# PIC16C73

## PIC16C73 Rev. A Silicon Errata Sheet

## Clarifications/Corrections to the Data Sheet:

**FIGURE 1: WRITES TO TIMER1 (EXTERNAL CLOCK / OSCILLATOR MODE)**

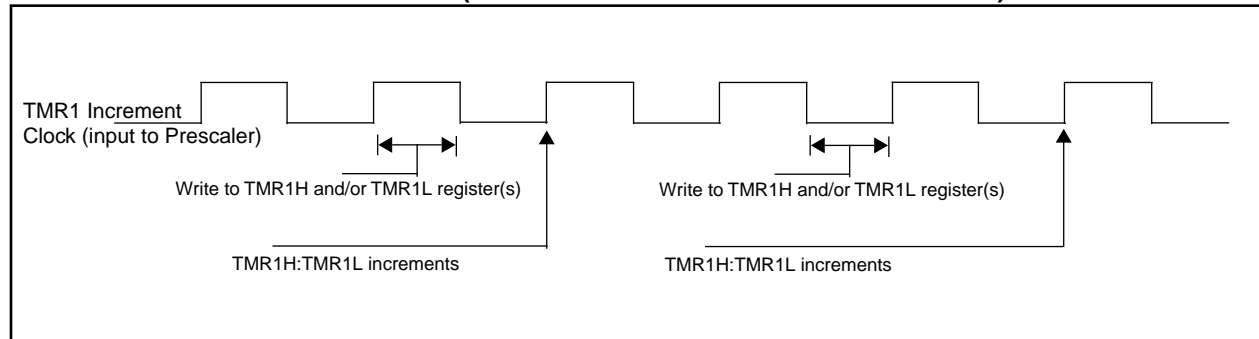
- a) The operation of Timer1 needs some clarification when the timer registers are written when the TMR1ON bit is set.

The internal clock signal that is the input to the TMR1 prescaler affects the incrementing of Timer1 (TMR1H:TMR1L registers and the Timer1 prescaler). When the Timer1 registers are NOT written, the Timer1 will increment on the rising edge of the TMR1 increment clock.

When the TMR1H and/or TMR1L registers are written while this clock is high, TMR1 will increment on the next rising edge of this clock.

When the TMR1H and/or TMR1L registers are written while this clock is low, TMR1 will not increment on the next rising edge of this clock, but must first have a falling clock and the rising clock for TMR1 to increment.

Figure 1 shows the two cases of writes to the TMR1H and/or TMR1L registers. Due to the  $V_{IH}$  and  $V_{IL}$  thresholds on the oscillator/clock pins, external Timer1 oscillator components, and external clock frequency, the Timer1 increment clock may not be of a 50% duty cycle.

The TMR1 increment clock is out of phase of the T1OSO/T1CKI pin by a small propagation delay.
